Memo

Re: Review of *LNAPL Interim Measure Containment Work Plan for the Bulk Fuels Facility Spill, Solid Waste Management Units ST-106 and SS-111*, by Kirtland Air Force Base, dated November, 2010

Figure 1. Proposed Containment System (taken from Interim Measure Containment Work Plan, November 2010)

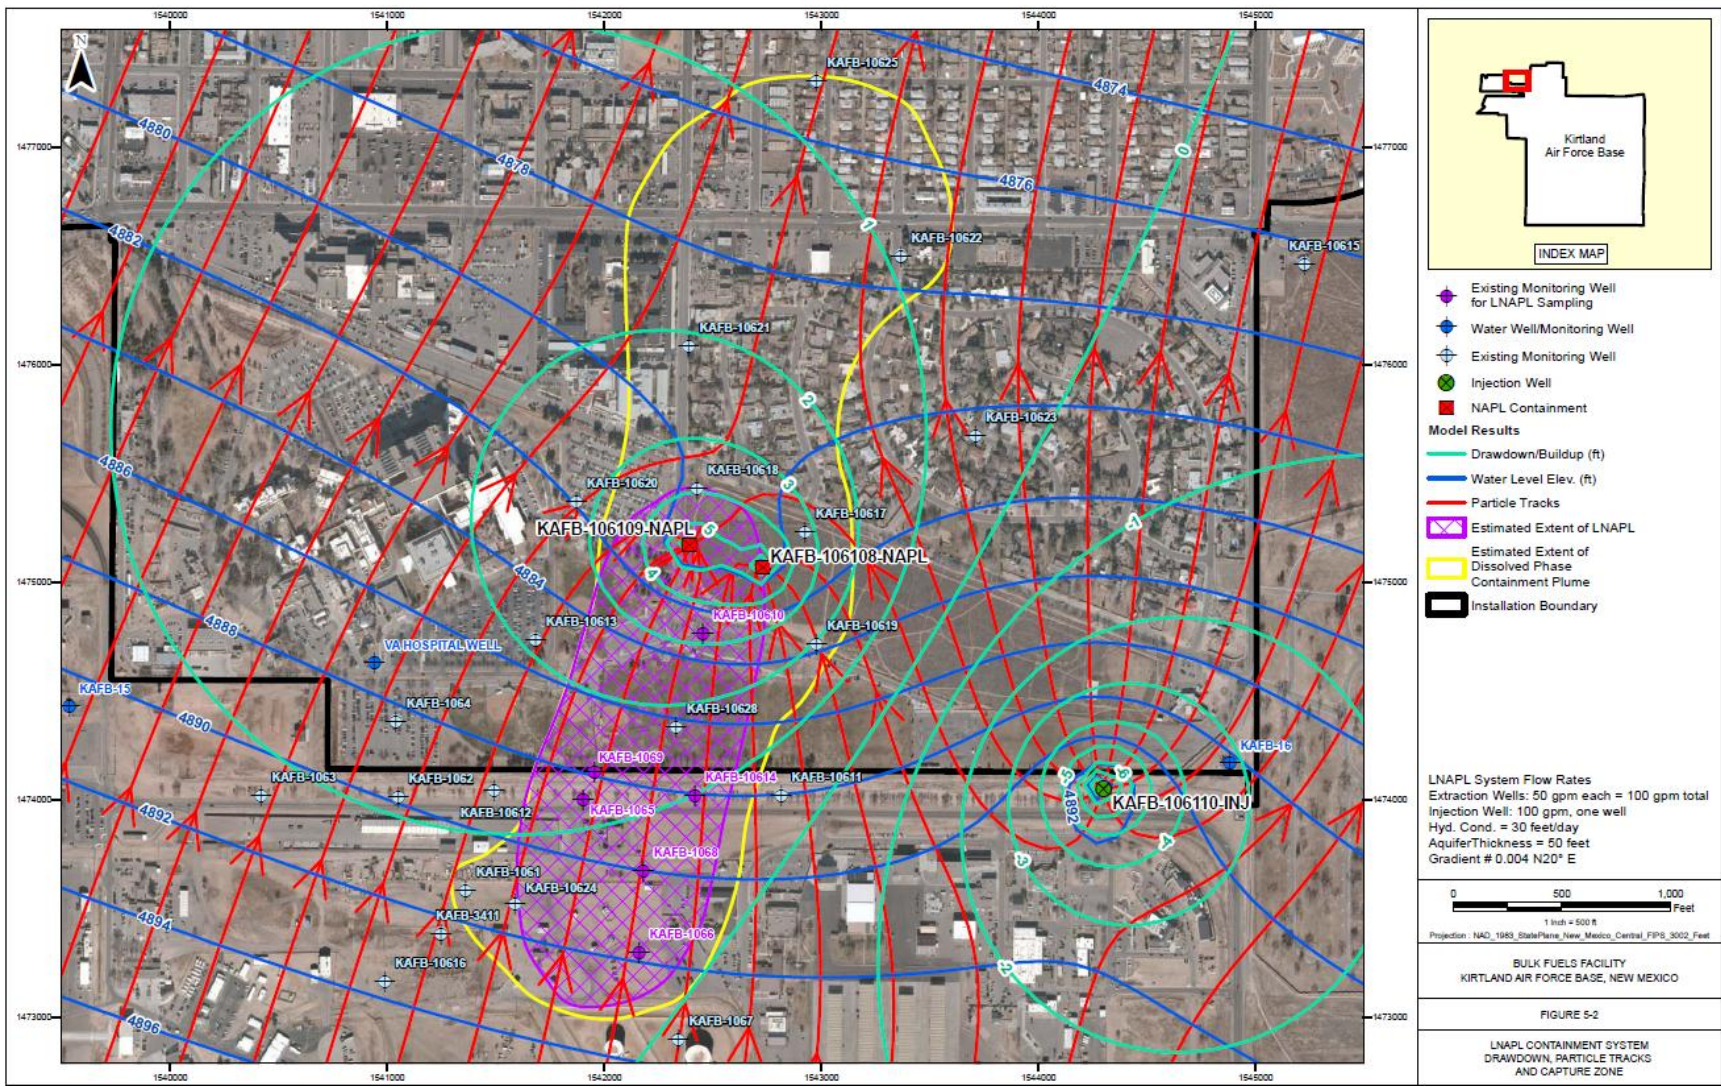
The proposed location and screened interval of the injection well raises the possibility that injection fluxes could accelerate the movement of dissolved phase contaminants to the downgradient public supply wells. In the absence of any groundwater quality data for the injection interval, assuming there is no contamination creates a risk of further compromising the aquifer. A major concern is that by locating the injection well cross-gradient from the known plume, treated water will be dispersed into a clean cell of the regional aquifer. Contaminated water will be introduced to a location where it currently does not exist. Also, there are no wells proposed down gradient of the injection wells to monitor either the resulting levels of contaminants or resulting injection fluxes. The WUA believes this proposed activity is counter to the purpose of the aquifer restoration effort we all want for our ratepayer's water resources.

Possible mitigation includes constructing the injection well with the longest screen length feasible or else placing the injection screen much deeper than the bottom of the extraction well screens. Mr. James Bearzi, Bureau Chief of the NMED's Hazardous Waste Bureau, however, indicated during the public meeting on January 12, 2011, that NMED will not accept a design unless the injection is upgradient of the extraction wells. The Water Authority supports the NMED's position on the injection well location.

2. Move location of proposed injection well upgradient of the interim containment system, so injected water can be potentially captured by the extraction wells.

Figure 2. Simulated Drawdown Contours for 100-Foot-Thick Aquifer

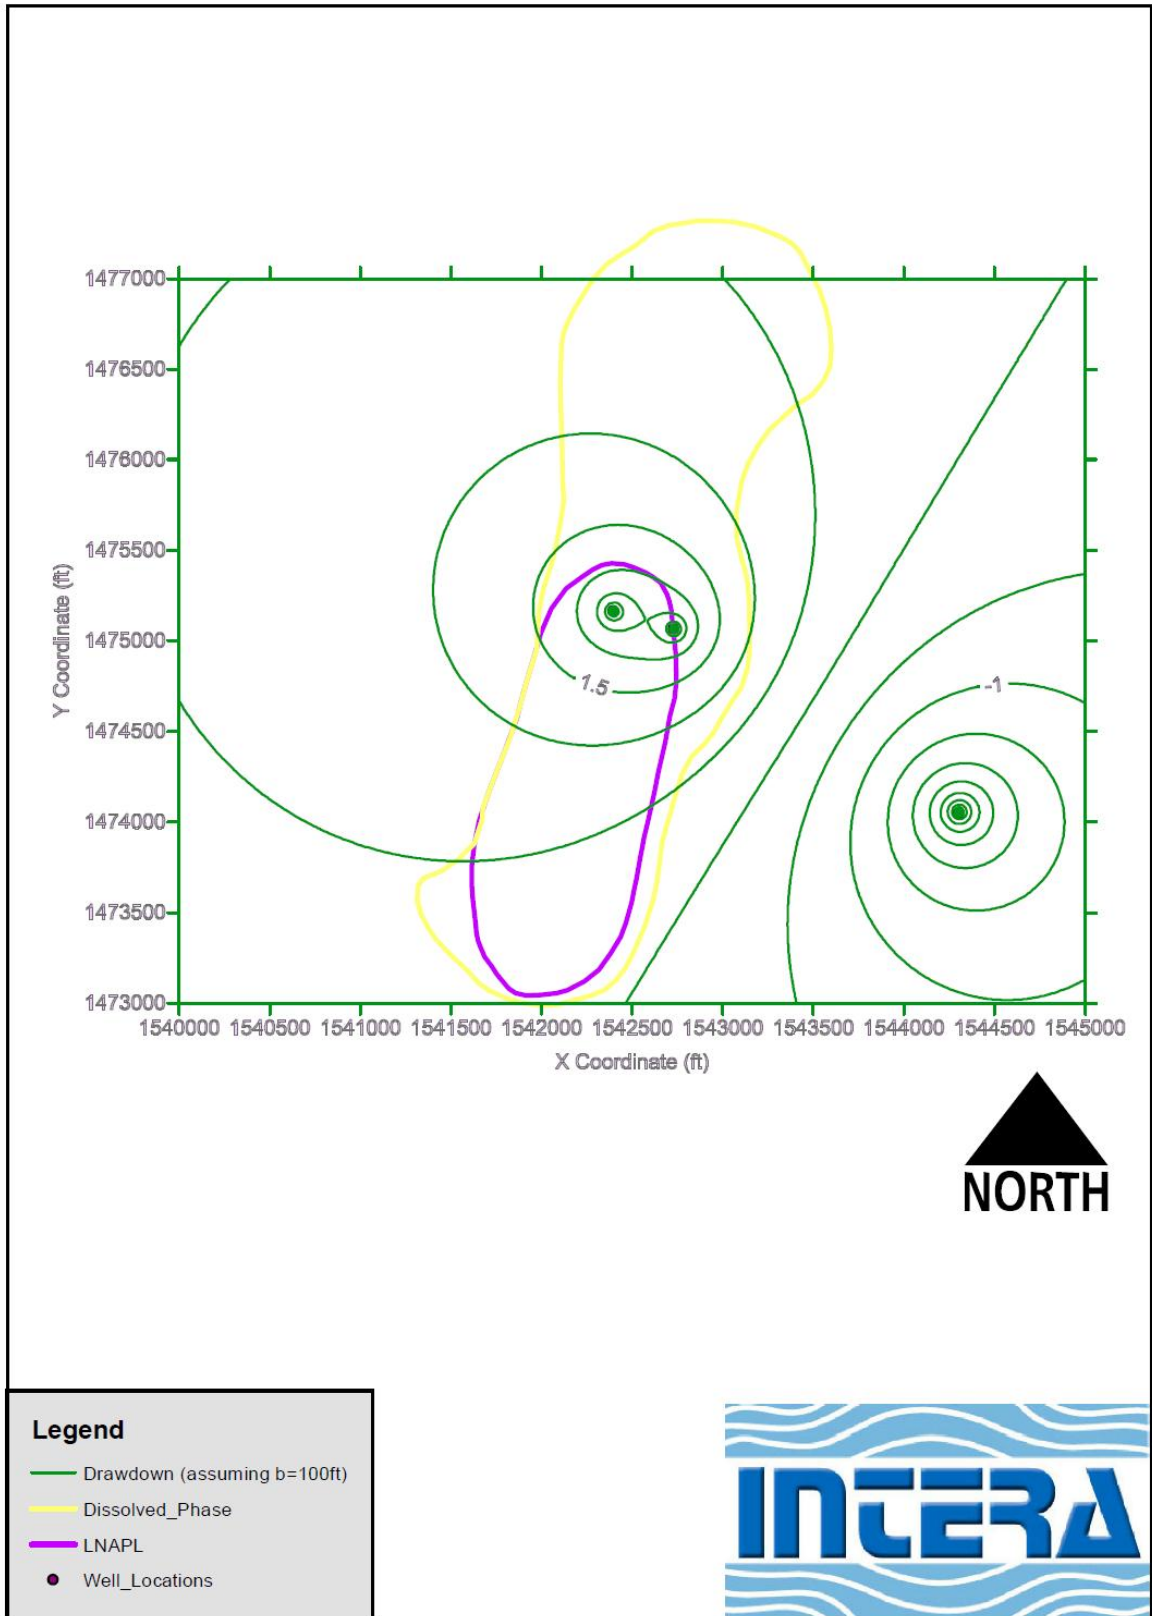
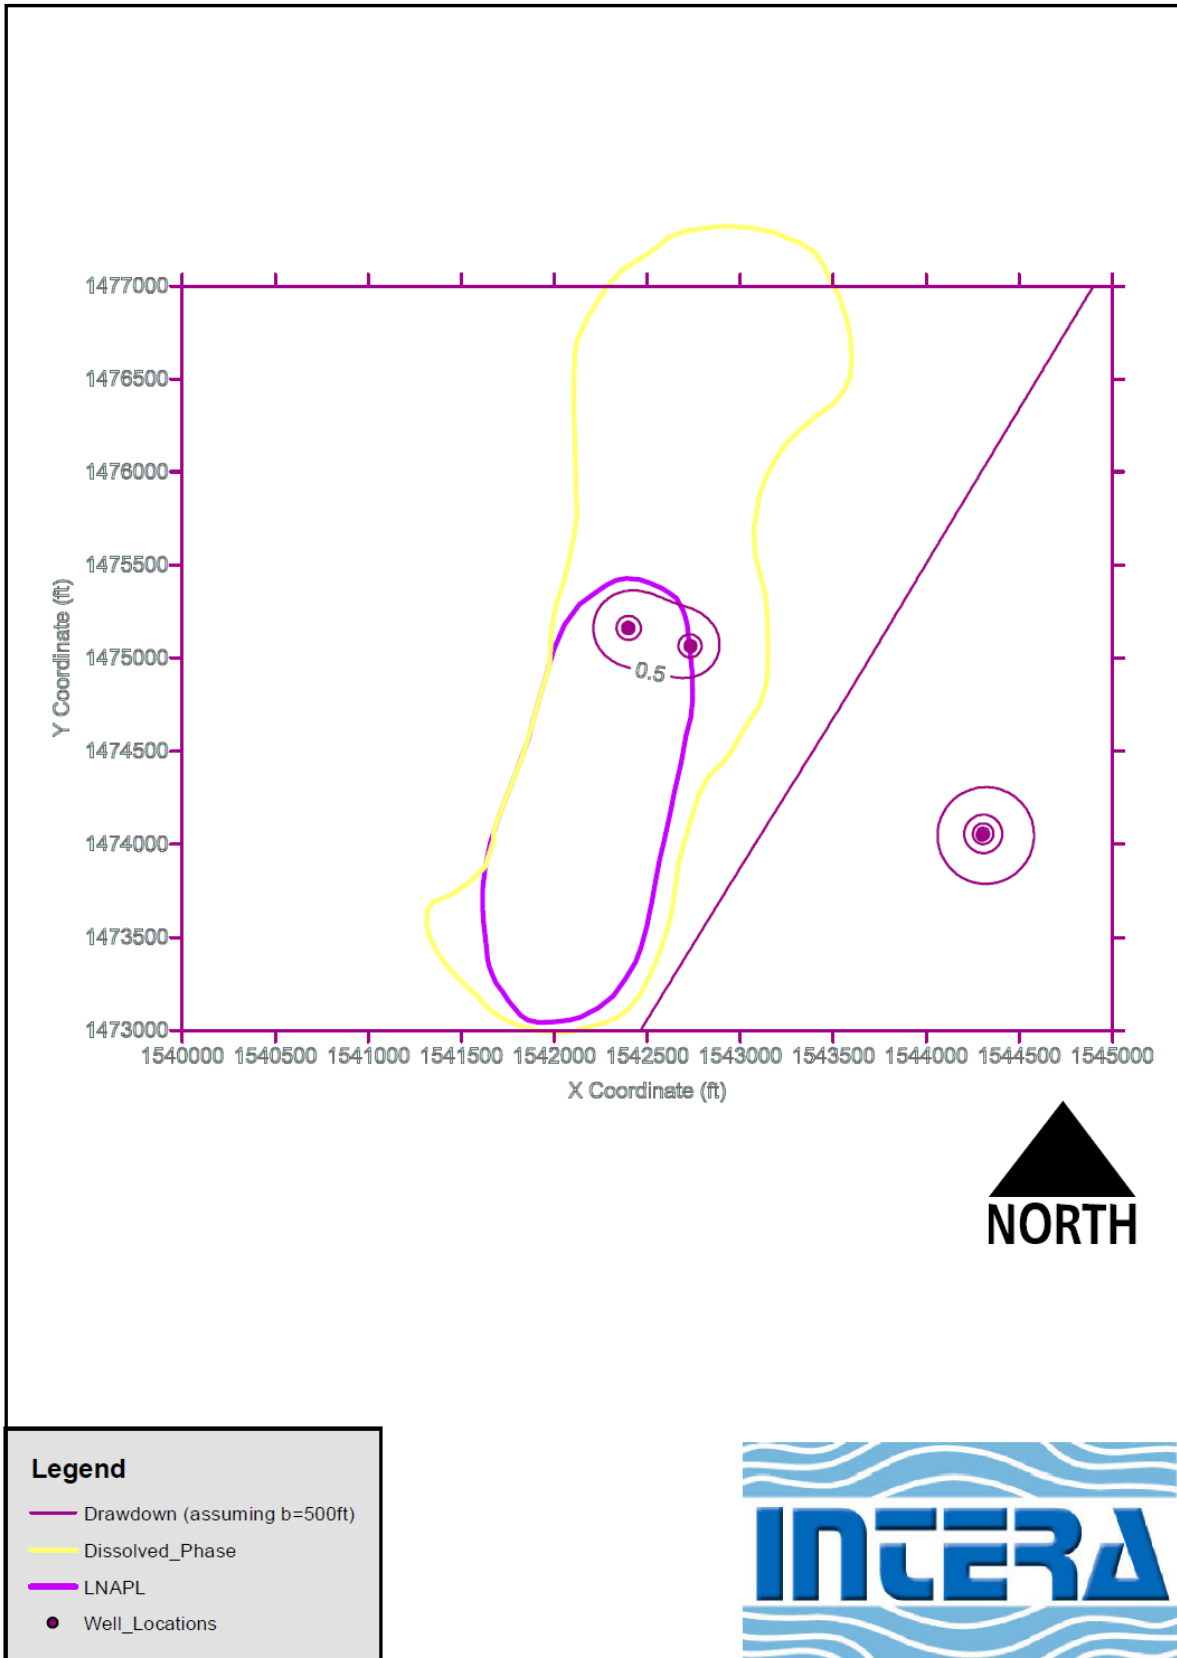
Our reviewers believe, as do we, that the true aquifer thickness is not 50 ft in the vicinity of the LNAPL lens. Several area production wells have screened intervals that are 500 ft bgs or greater. Since drawdown is inversely proportional to aquifer thickness, the work plan estimate is not sufficiently conservative. INTERA's simulated system shows drawdown to be roughly four ft at the downgradient edge of the LNAPL lens (Figure 1). They used the forward modeling tool in AQTESOLVE (HydroSOLVE, 2009) to simulate drawdown contours from the containment system using the same aquifer parameters and more realistic estimates of aquifer thickness, 100 and 500 ft. INTERA's analysis could not accommodate the regional hydraulic gradient, so the shape of the drawdown contours differs slightly from those in the KAFB work plan. With an aquifer thickness of 100 ft, drawdown was approximately 1.5 ft at the LNAPL edge, whereas the 500 ft thick aquifer yielded drawdown of 0.5 ft at the same location (Figures 2 and 3).

1. Use a more appropriate aquifer thickness in design simulations for the interim containment system. Explain the how the simulations of a 50-ft-thick aquifer accommodate a 100-ft screened interval for the injection well.
